## USC SOM #28 Sim II

State Project Number: H27-Z325

September 27, 2018

### ADDENDUM NO. 4

1 FIRST FLOOR - FINISH FLOOR PLAN  
1/8" = 1'-0"

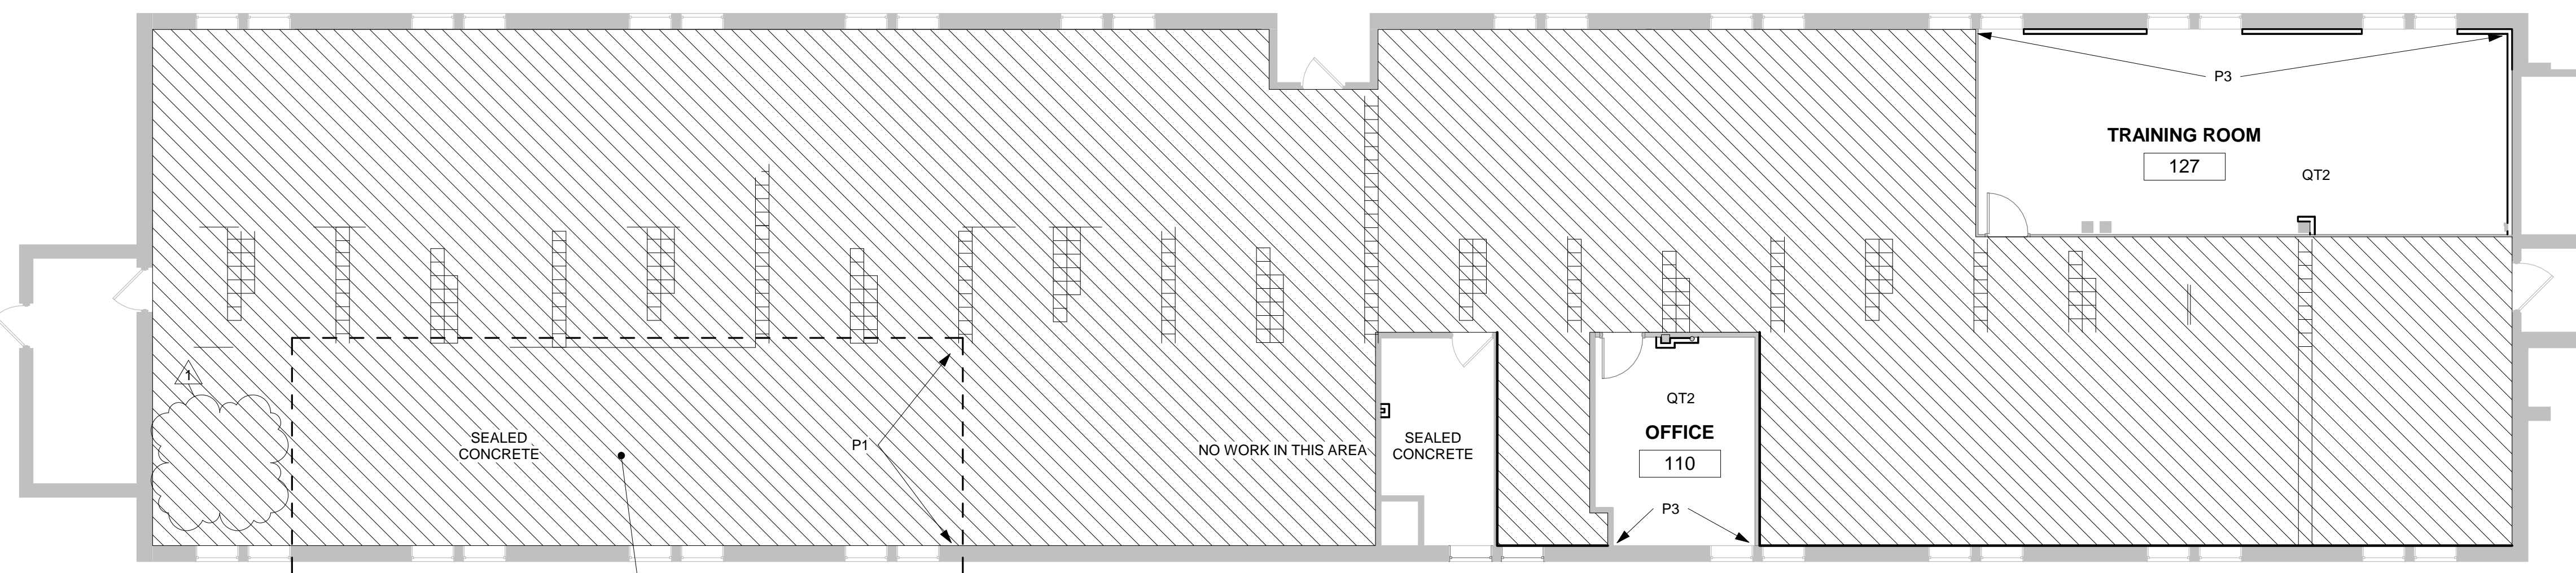
3. Question: Sheet A701, Finish Specification, lists QT 1 with a note to see finish floor plan for floor pattern layout. Is there a pattern for the Quartz Tile?

4. Question: Sheet A701 lists QT 2 as the floor finish in two spaces. Should this be QT 1 as described in the legend?  
**a. Answer: See revised sheet A701, dated 8/10/2018, Revised 9/27/2018.**

5. Question: Sheet A701, Finish Floor Plan, space Sim Storage 116 is shown with QT 2 noted. Is the correct floor finish for space 116 under alternate 1 base only placed within the area shown for that space on sheet A102?

**a. Answer: There is no floor pattern for this area. All floor tile to run in the same direction. Coordinate with existing floor tile and install to match direction.**

**a. Answer: QT2 should is not required in Sim Storage 116. See revised sheet A701, dated 8/10/2018, revised 9/27/2018.**
